THE APEX - LH 'TRADITIONAL'

REVISION LOG

Lot 160 - Duncan's Creek

ARCHITECTURAL DRAWINGS

FIRST FLOOR PLAN 'TRADITIONAL'
SCALE: 1/8"=1'-0" ON 11x17, 1/4"=1'-0" ON 22x34

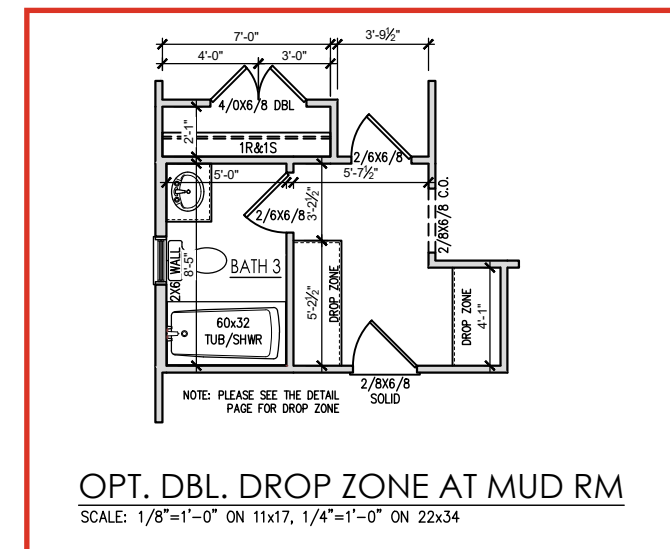
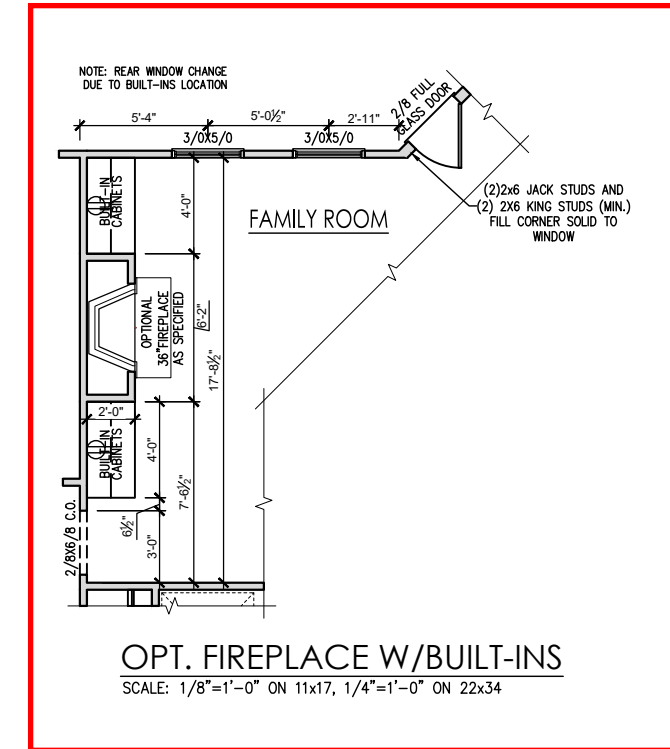
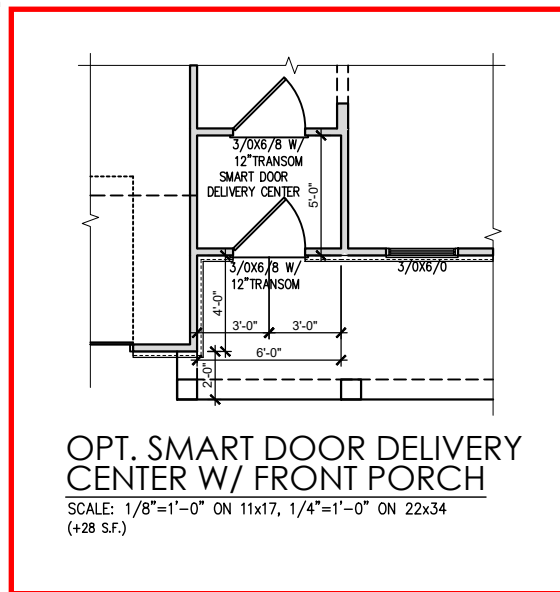
Redline Revision: Mark out window at Family Room and show the dbl drop zone. - JJ 9-19-2024

Double Drop Zone - 2.1.1a
